2. Historic District Commission Meeting Packet 3-27-18

CITY OF YPSILANTI
Agenda
Historic District Commission
Tuesday, March 27, 2018 - 7:00 p.m.
City Hall, Council Chambers, 1 S. Huron
Ypsilanti, MI 48197

CITY OF YPSILANTI
Agenda
Historic District Commission
Tuesday, March 27, 2018 - 7:00 p.m.
City Hall, Council Chambers, 1 S. Huron
Ypsilanti, MI 48197

3 Bay Window Detail Elev.
SCALE: 3/8" = 1'-0"

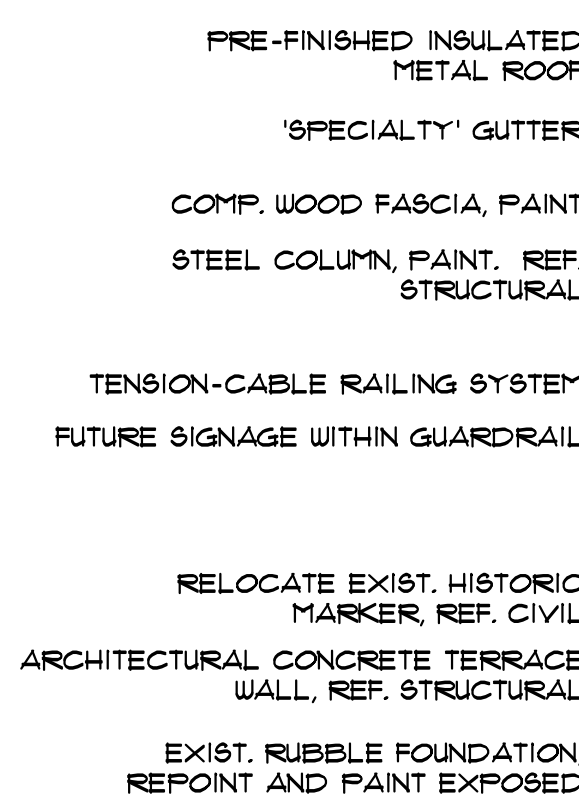
4. Staff has advised that the change to the PVC material on the front oriel window may be considered inappropriate.
5. All the lighting on the plans except the Lithonia light poles at the rear of the lot (labelled "C" on the plans) were already included in the original submission and approved by the commission.

Move to approve the amended plans for work at 400 N River as submitted in the application dated March 8, 2018 with lighting plans dated 6-21-2017 and elevations dated 8-24-2017 with the condition that the oriel window materials be changed back to a smooth composite wood siding, as this material is more appropriate.

PROPOSED BUILDING BANNER BRACKET FOR RIVERSIDE ARTS CENTER (DTE BUILDING)

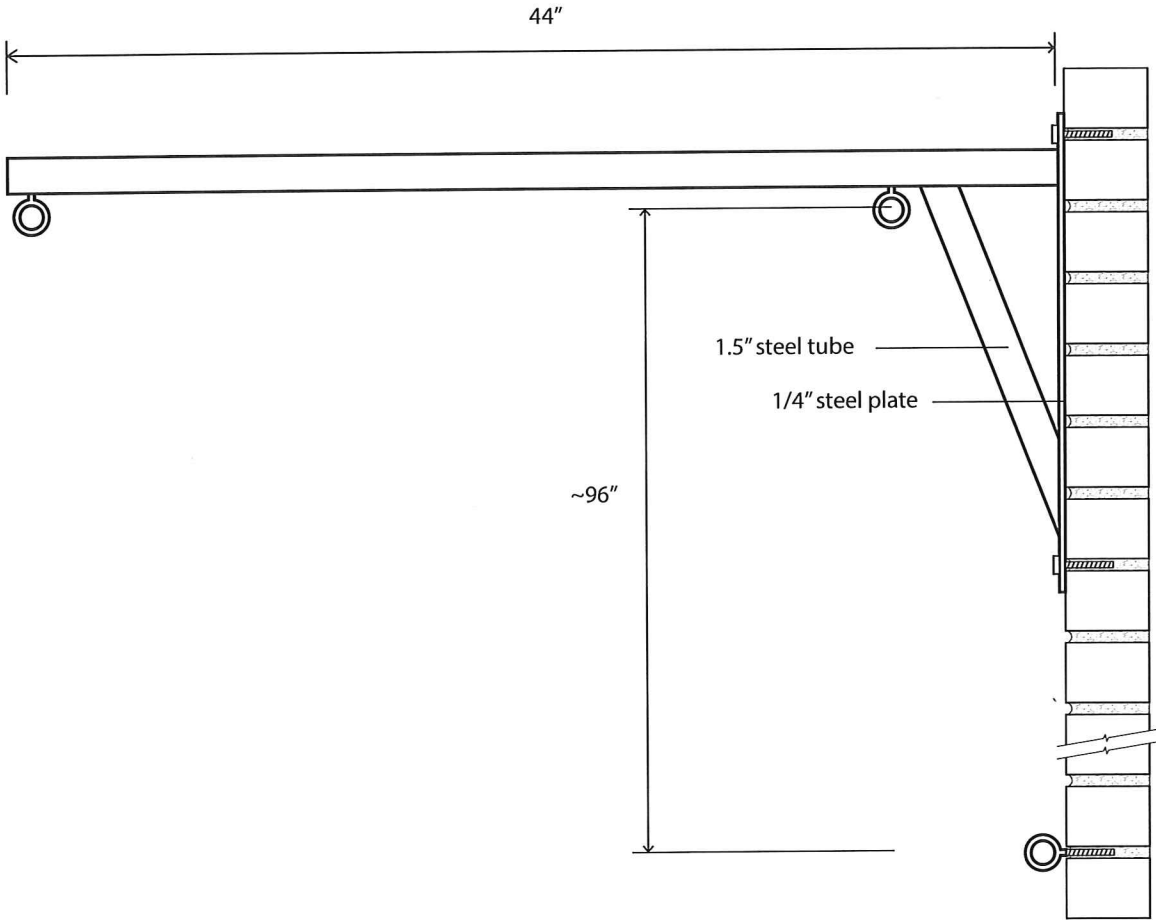
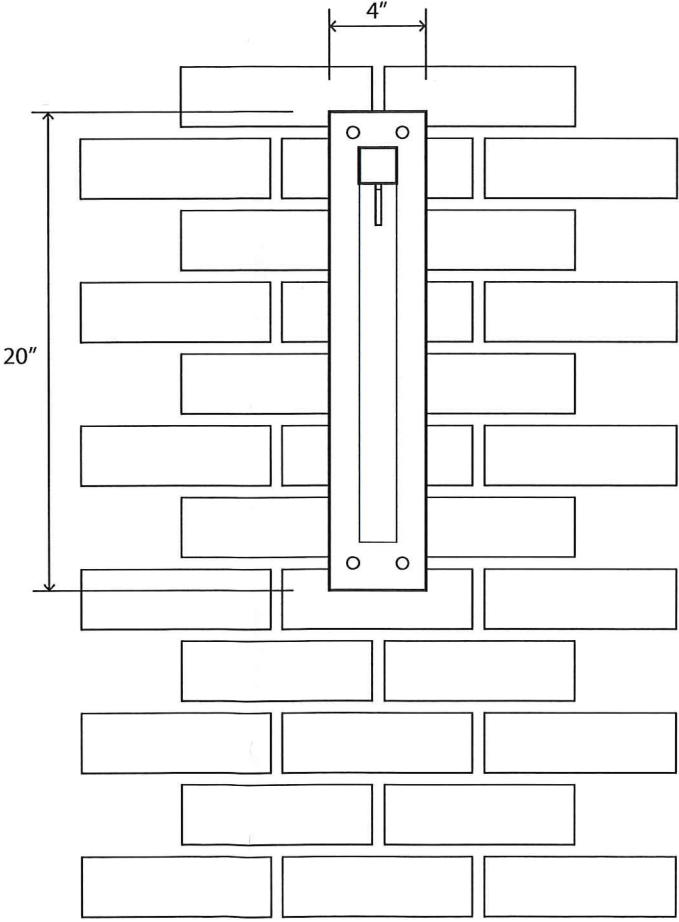
1. The applicant attended a previous HDC meeting as a study item; the plans for the signage have changed since then.
2. The applicant plans to install adhesive vinyl signage and art to the windows on both the Riverside Arts and DTE buildings.
3. Signage will be installed on the main door and transom window of 76 N Huron, the elevator tower, and on the upper windows and the door of 64 N Huron.
4. The "R" logos, the "Riverside Arts Center" name and the banners with the name or logo of the art center are considered signage per the zoning ordinance. The rest is considered art.
5. HDC to verify how the bracket is to be installed.
6. All signage is subject to zoning ordinance requirements.
7. A building department permit will be required for this work and should be obtained prior to the start of any work.

work to the windows on both properties and the installation of a black painted steel frame bracket for a banner sign as indicated on the submitted plans. The bracket is to be installed in the mortar joints on the building.
